**AP1000 Design Certification Review
Draft Safety Evaluation Report Open Item Non-Proprietary Response**

AP1000 DESIGN CERTIFICATION REVIEW

Draft Safety Evaluation Report Open Item Response

DSER Open Item Number: 15.2.7-1

Figure 8

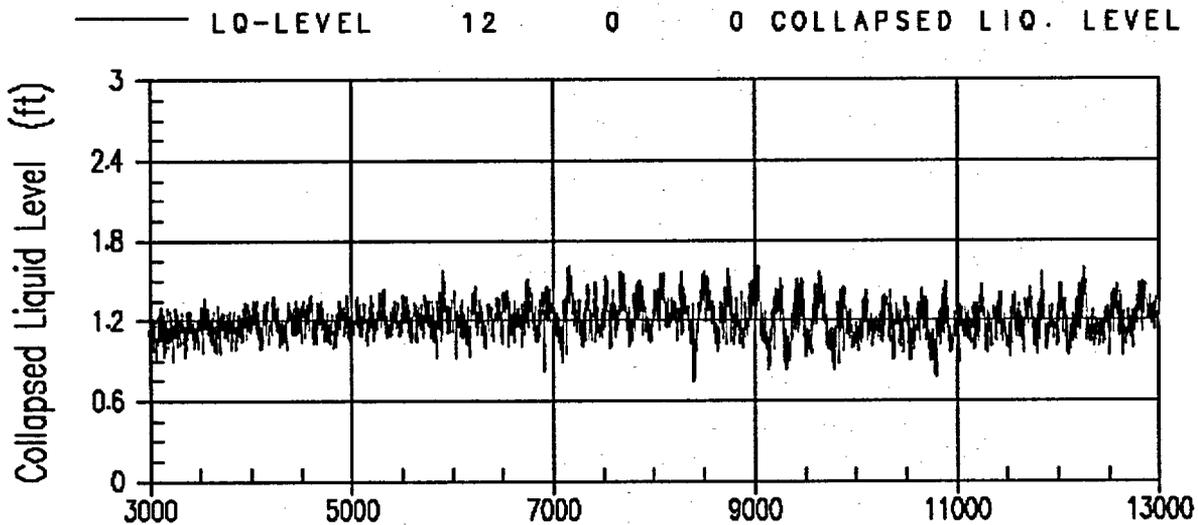
Figure 8 shows that the mixture level is located in proximity of the hot leg centerline.

Figure 9

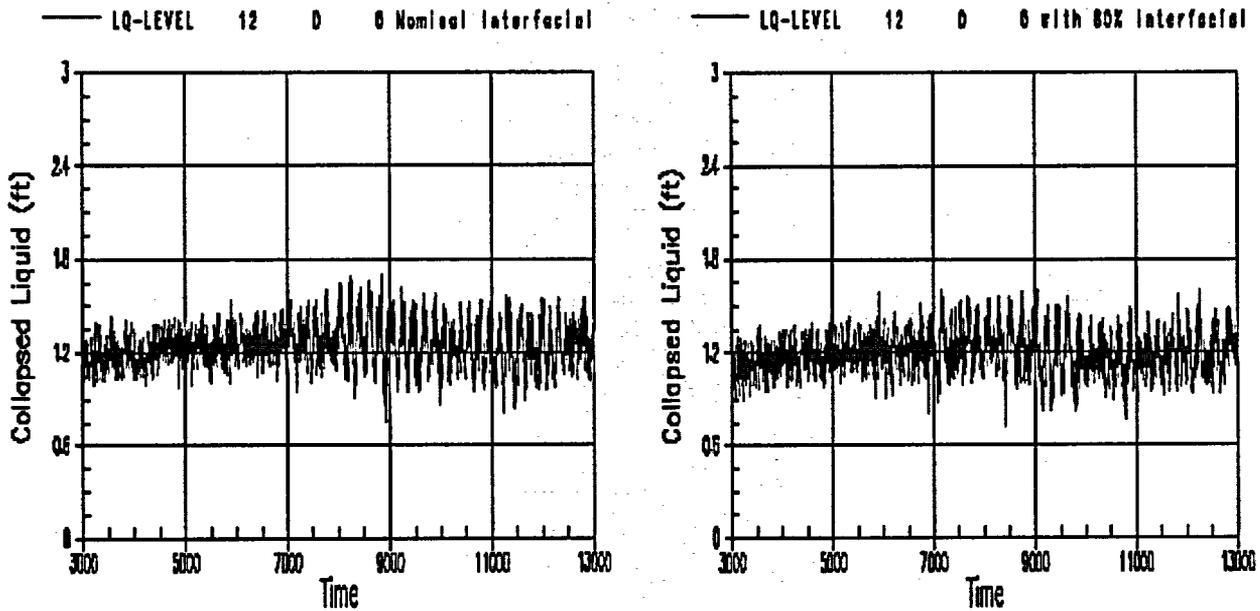
It is worth to note that the LTC case was analyzed with both nominal interfacial drag model and with 20% reduced interfacial drag model and it was observed that the hot leg levels from these calculations were nearly identical as shown in Figure 9.

Figure 11

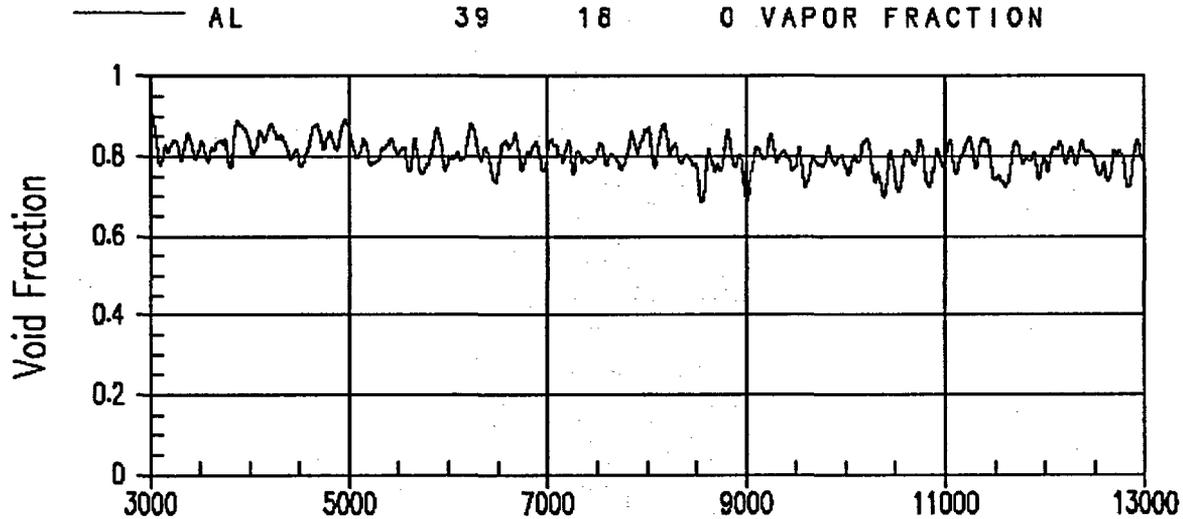
The predicted void fraction at the top of the core hot assembly is approximately 0.8 during the transient (Figure 11) which is another indication that sufficient liquid is provided at the top of the core preventing core heat-up from occurring.

Figure 12

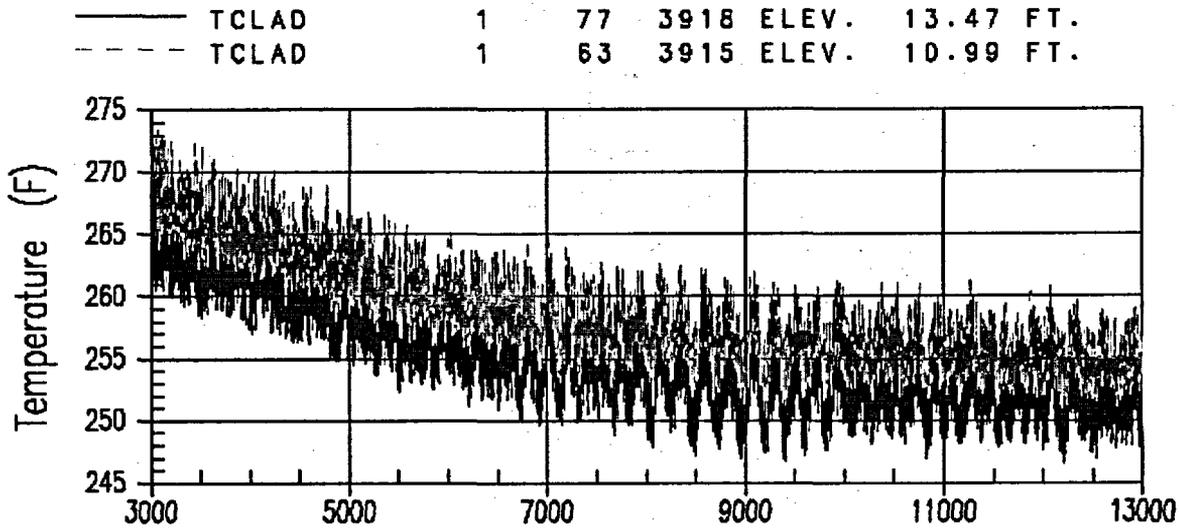
Figure 12 shows that the clad temperature in the top region of the core is always close to the saturation temperature and no heat-up excursion is predicted to occur.

Figure 21.5-1.14 Downcomer Pressure Comparison

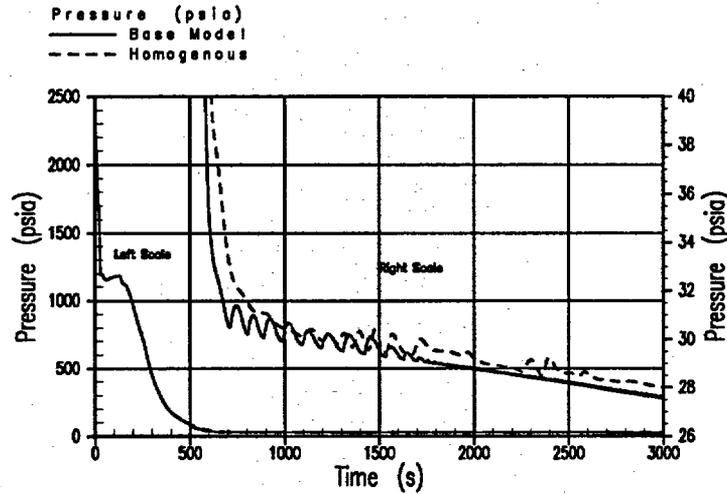
Figure 21.5-1.14 presents a comparison of the upper downcomer pressure between the base and sensitivity cases. As can be seen, the sensitivity case results in higher upper downcomer pressure and subsequently results in delayed IRWST injection (Figure 21.5-1.15). This can also be observed in the intact DVI line flow, which comprises all intact injection flow components (i.e. Accumulator, CMT and IRWST) per Figure 21.5-1.16. As expected, the initial ADS-4 liquid discharge is much higher (Figure 21.5-1.17) until the inventory which resided in the upper plenum and hot leg regions was depleted (Figure 21.5-1.18). The net effect is a decrease in the ADS-4 vapor discharge rate (Figure 21.5-1.19) and subsequently higher RCS pressures.

Figure 21.5-1.25 Pressurizer Mixture Level Comparison

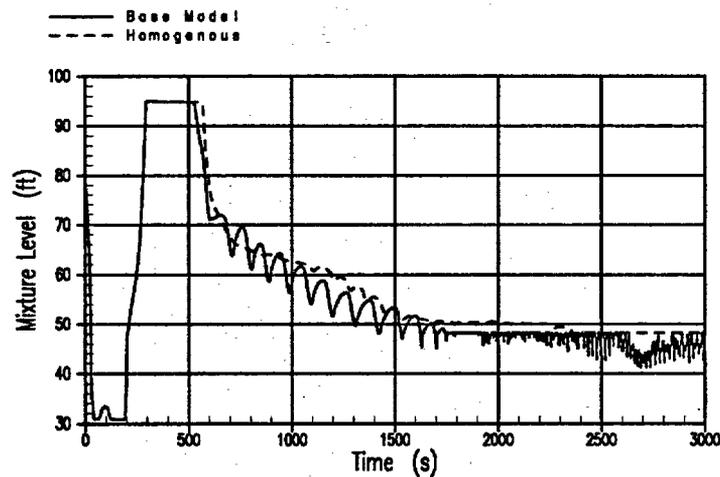
The pressurizer mixture level response (Figure 21.5-1.25) reflects the change in pressure response (Figure 21.5-1.14) observed in the model as a result of the sensitivity study.
